CITY OF APPLETON

MEMORANDUM

Date: July 23, 2025
To: Plan Commission
From: Don Harp, Principal Planner
Subject: Preliminary Plat – Glenmore Park

Preliminary Plat of

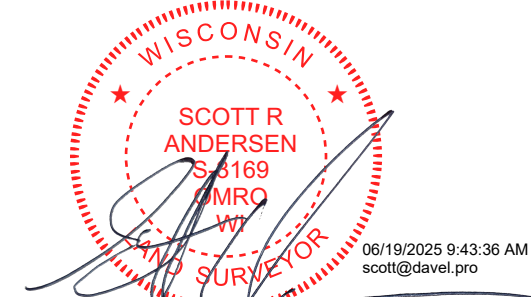
It appears, Outlot 4 does not satisfy the minimum 6,000 square foot lot size requirement of the R-1B Zoning District. Also, it appears the minimum 50 foot lot width requirement of the R-1B Zoning District is not satisfied. Outlots may be conveyed regardless of whether or not it may be used as a building site for a residential dwelling unit. However, the Municipal Code specifies all lots, including outlots, shall comply with the minimum lot size and width requirement of the respective zoning district.

Analysis: Lots 45, 46 and 47 are double frontage lots. The creation of double frontage lots cannot be avoided because CTH "E" is governed by Outagamie County Highway Access Restrictions.

Analysis: Prior to Final Plat approval, Outlot 4 shall comply with Section 17-3(c)(6) and Section 23-93(g)(1) of the Municipal Code or add a note on the final plat specifying, "The lot is not buildable at this time as it does not meet the lot area and lot width (if applicable) requirements per the Appleton Municipal Code."

1. Grant relief from the double frontage lot requirements for proposed Lots 45, 46 and 47, per Section 17-26(c)(2) of the Municipal Code and as stated in the staff report.
